Addendum to Recall Campaign #90

04V-114

AFFECTED: 2000-2004 Winnebago and Itasca P-series models covered under Recall Campaign 90 – Addition of LP Gas Tank Mounting Cradle Brackets

SUBJECT: Alternate LP Tank Straps

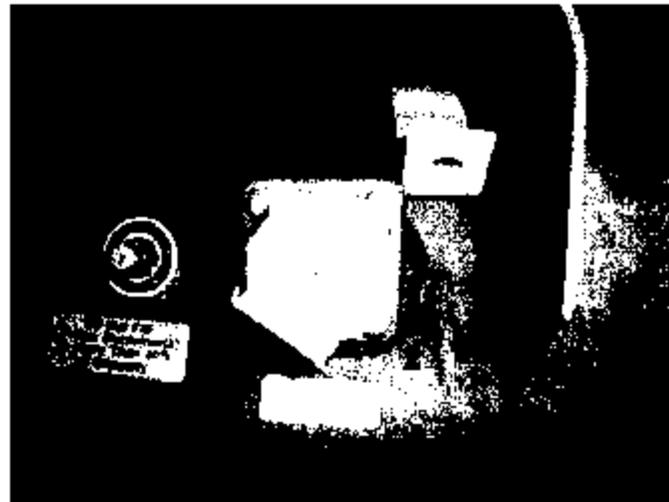
We have become aware of possible variations on some LP gas tanks being fitted with new LP gas tank mounting cradles and straps under Recall Campaign 90. This condition may exist on vehicles equipped with diesel generators.

Due to a variation in tank component locations there may be insufficient clearance between the guard shield (1) and the nearest tank fixture (2) for the proper installation of the 1 1/2" cradle strap (3) supplied in the recall kit, as shown in the photo.

To remedy this condition Manchester, the tank manufacturer, is supplying a 3/4" narrower strap for installation at this location. The narrower strap should be used only in the location as shown in the photo, and only when necessary.
